### APPEAL SUMMARY

<b>Appeal ID:</b> 23281	<b>Project Address:</b> 7336 N Central St
<b>Hearing Date:</b> 1/8/20	<b>Appellant Name:</b> Adam Clough
<b>Case No.:</b> B-002	<b>Appellant Phone:</b> 503-720-6001
<b>Appeal Type:</b> Building	<b>Plans Examiner/Inspector:</b> Jason Butler-Brown, Amit Kumar
<b>Project Type:</b> residential	<b>Stories:</b> 2 <b>Occupancy:</b> N/A <b>Construction Type:</b> N/A
<b>Building/Business Name:</b> N/A	<b>Fire Sprinklers:</b> No
<b>Appeal Involves:</b> other: Demolition (Pool)	<b>LUR or Permit Application No.:</b>
<b>Plan Submitted Option:</b> pdf [File 1] [File 2] [File 3]	<b>Proposed use:</b> N/A

**Geotechnical Consultation Report  
Clough Residence Swimming Pool Demolition  
7336 North Central Street  
Portland, Oregon**

## **Swimming pool demolition project - DECEMBER 2019**

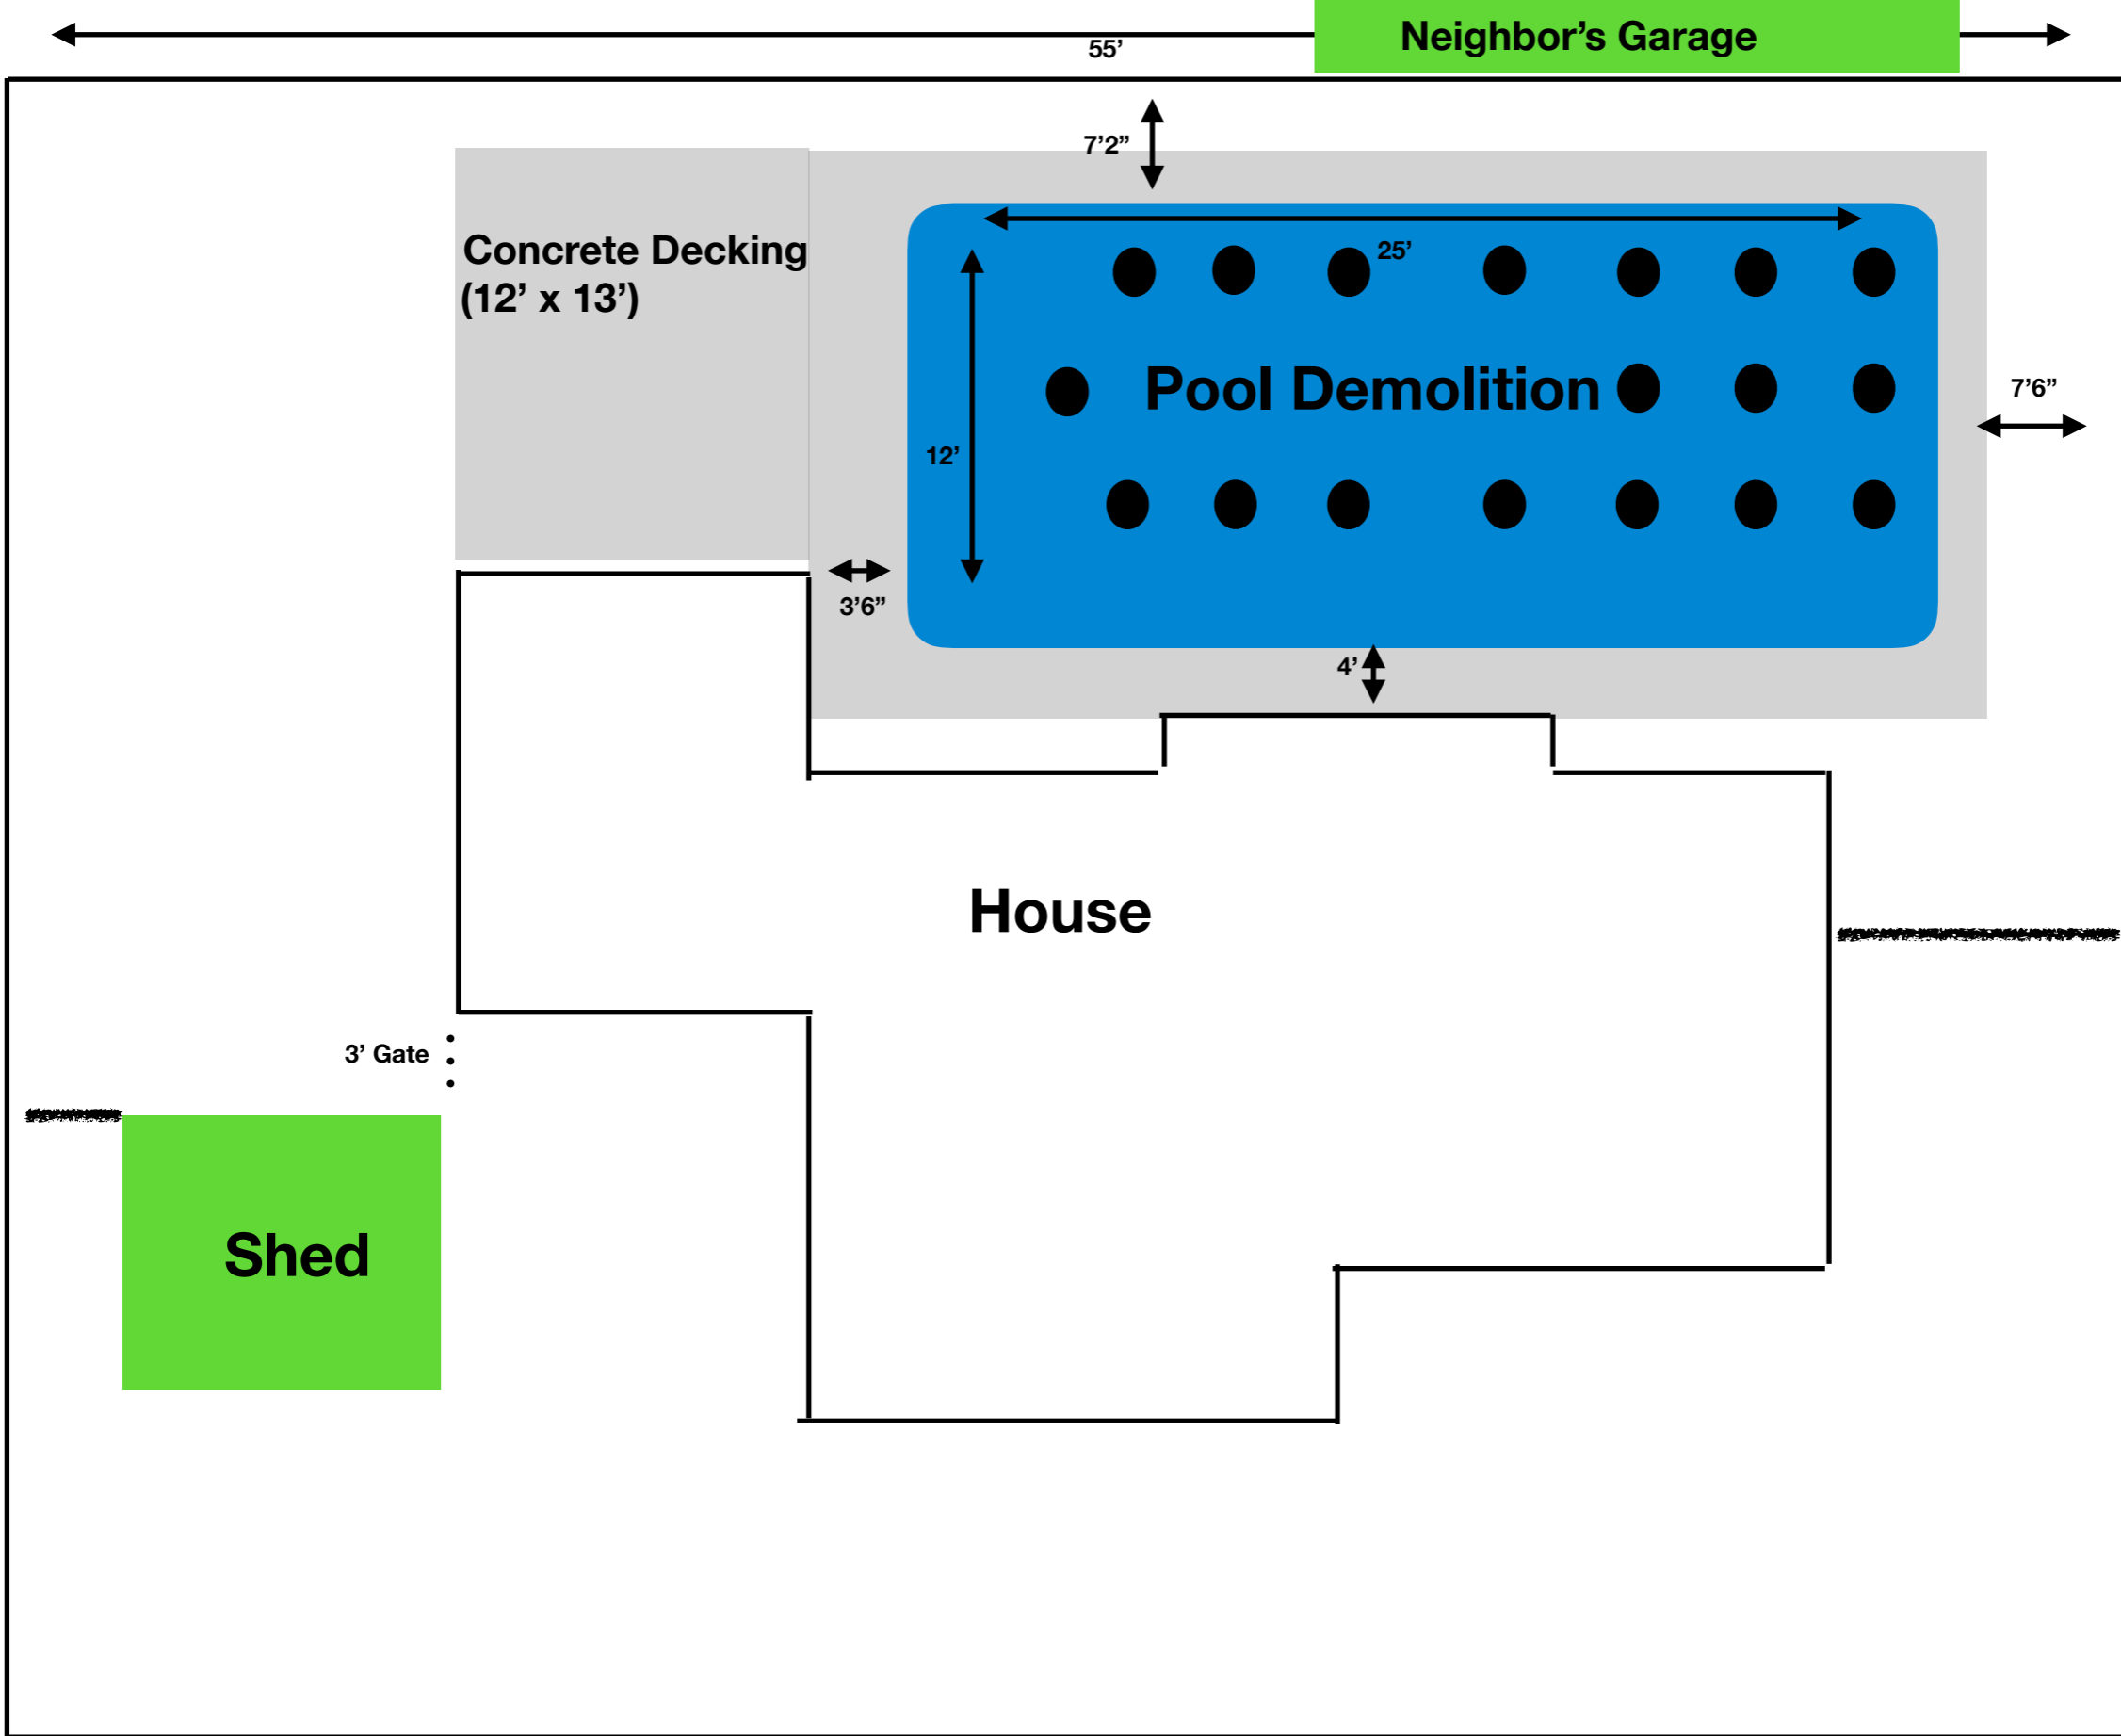
**Vertical  
walls to  
remain  
12" sub-  
grade**

**Drainage  
through  
18 6"  
diameter  
holes**

**24.70.80  
Fills**

**Replace  
with  
plants,  
patio,  
crushed  
rock**

**Demolition of pool with partial structure to remain in place: Granted provided the recommendations of the geotechnical report are implemented.**
